**MUNICIPAL PLANNING COMMISSION
WEDNESDAY AUGUST 17, 2016 – 12:30 PM
TOWN OF REDCLIFF**

Development Permit Application **Background Information / Review**

Applicant:	FarWest Land & Properties Inc.
Civic Address:	638 2 Street SE
Legal Address:	Lot 39-40, Block 8, Plan 1117V
Land Use:	R-1 Single Family Residential District
Development Officer:	Brian Stehr

2nd Street SE

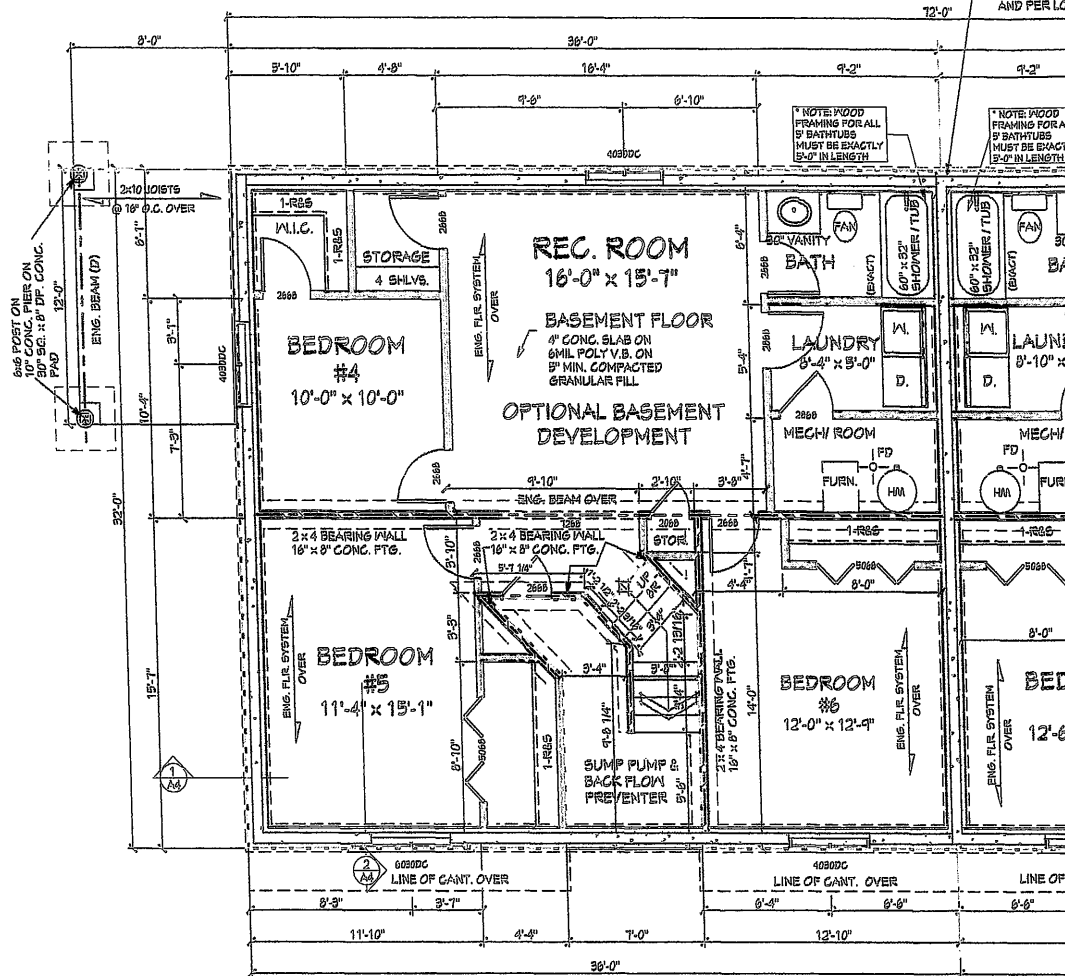
- Town Administration supports the proposed development, and thinks that the proposed development will positively impact the neighbourhood.
- 7th Avenue is a low volume local road and is not planned to be more than a local road. The road ROW is currently 20 metres compared to new developments which are 16.0 metres wide.

- The Applicant has indicated that the property will be subdivided in the future;
- The Town of Redcliff has no water or sanitary sewer mains in 7th Avenue and cannot provide these services from 7th Avenue;

- All servicing of the lot must come from 2nd Street. The layout of the semi-detached dwelling would require an instrument registered to title to allow this, if the lot is subdivided;

- If the semi-detached dwelling is serviced with a single service the cost of changing the servicing to two (2) services.
- The Land Use Bylaw requires a six (6.0) meter setback on front yard setbacks, and a six (6.0) meter setback on the rear yard setbacks. The Subdivision Approving Authority could not approve a subdivision under the current Land Use Bylaw as it would be in contravention of the Land Use Bylaw.

1. The exterior of the home to be similar or compliment adjacent properties;
2. Prior to release of the Development Permit the Applicant shall:
 - a. Provide a site grading plan to the satisfaction of the Director of Planning & Engineering;
 - b. Apply for and receive permission from Council to install two (2) services into the property;
 - c. Provide to the Development Officer documentation that they have paid to have the Town of Redcliff's Public Services Department to install:
 - i. water and sanitary sewer services to the edge of property,
 - ii. curb crossings at the driveway locations,
 - iii. Sidewalk along 7th Avenue adjacent to the property,

1. The exterior of the home to be similar or compliment adjacent properties;
2. The Applicant shall apply for and receive permission from Council to install two (2) services into the property;

3. The Applicant shall enter into a Development Agreement with the Town of Redcliff with respect to:

Estimated Value
a. Provision of a site grading plan to the satisfaction of the Director of Planning & Engineering;	\$1000.00
b. The installation by the Applicant of:

i. water and sanitary sewer services to the edge of property,	\$7,000.00
ii. curb crossings at the driveway locations,	\$4,000.00
iii. Sidewalk along 7 th Avenue adjacent to the property,	\$5,000.00
